REQUEST

Current Zoning: UC (Uptown Core)
Proposed Zoning: UC(EX) (Uptown Core, Exception)

The petition proposes the redevelopment and expansion of existing stadium facilities on property developed with the Bank of America Stadium.

STAFF RECOMMENDATION

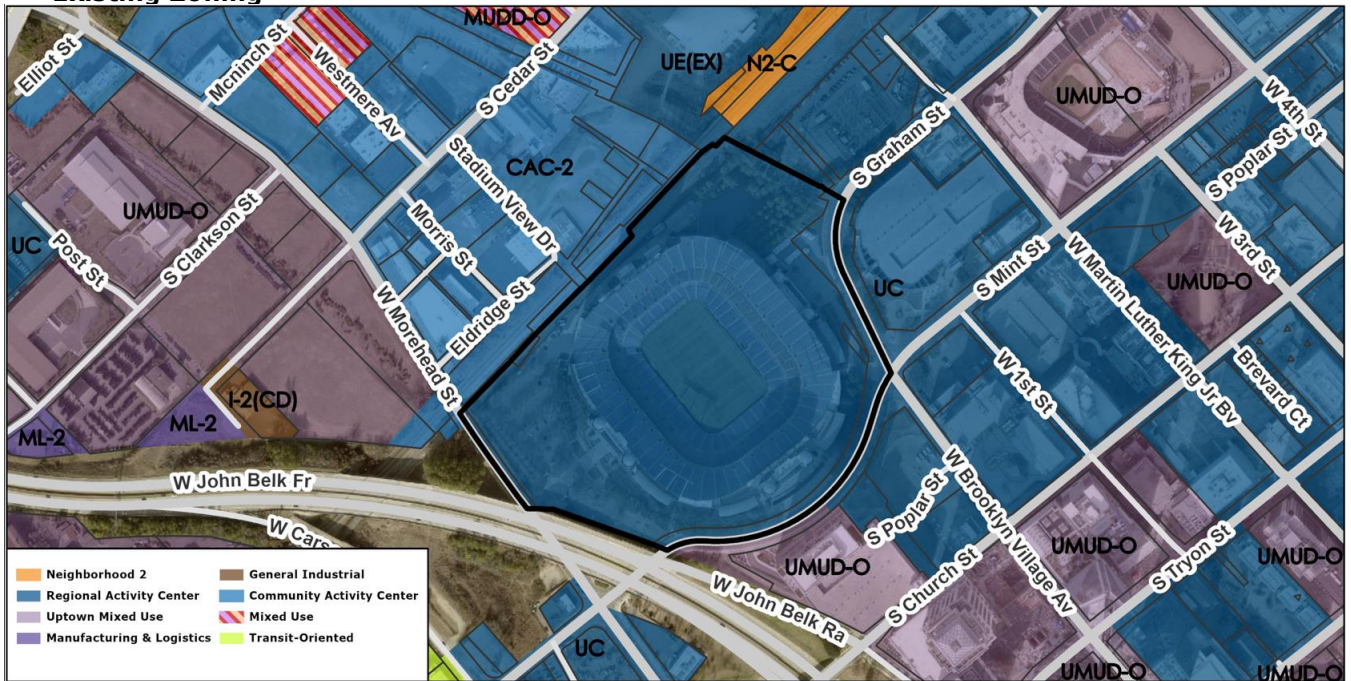
The site plan accompanying this petition contains the following provisions:

- Proposes Development Areas A1, B1, B2, and B3.
- Proposes to allow all uses permitted in UC including: stadium; practice/training facilities and field house; sports operations, activities, events, and wagering facilities authorized under State Law; Live Performance Venue-Indoor and Outdoor (including without limitation Temporary Outdoor Entertainment); Restaurant/Bar; Retail; Personal Services; Office; Reception Facility; Mobile Food and Retail Vendor; lodging and overnight stays, including without limitation for players, personnel, vendors, visitors and others associated with users of the allowed principal uses among other uses.

- Requests EX provisions and specifies that the required public benefits for the EX request includes the following:
 - Petitioner shall satisfy the public amenity public benefit category with the creation of publicly accessible open space areas to be maintained at a minimum of 25% greater area than full ordinance requirements for publicly open space as part of the site. At the time of land development permitting, such open space areas shall include elevated materials such as pavers or stone elements, decorative plantings/landscaping, seating elements, and pedestrian-scale lighting. Additional improvements to the open space area of the same categories must be installed prior to May 31, 2030 and will be particularly localized along the periphery of the open space away from locations of heavy security and pedestrian flow. The open space areas must have a minimum size of 1,500 square feet and a minimum dimension of ~~25'~~ 30' in any direction. The location of the areas may shift as development takes place or activities and operations are adjusted throughout the life cycle of the site. Such areas shall be closed periodically due to security and safety needs of associated events on the site.

- Requests EX provisions as follows below:
